• NOISE—GEAR “WHINE” HEARD IN PASSENGER COMPARTMENT • TRANSAXLE—GEAR “WHINE” NOISE HEARD IN PASSENGER COMPARTMENT	Article No. 01-5-7

MERCURY: 1999-2001 VILLAGER

Figure 1 - Article 01-5-7

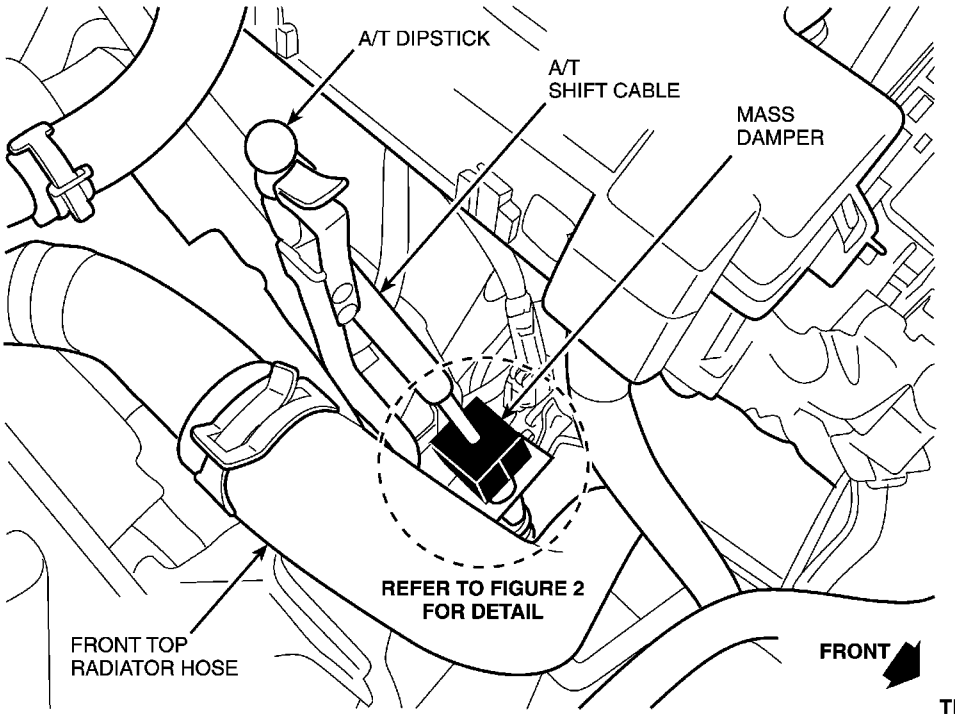
1. Road test the vehicle to confirm a gear whine noise is heard.
2. Install Mass Damper (XF5Z-7L256-AA) on the A/T shift cable so that it is positioned 10mm above the A/T shift cable rubber boot (refer to Figures 1 and 2).
3. Road test the vehicle to confirm the gear whine noise is resolved.
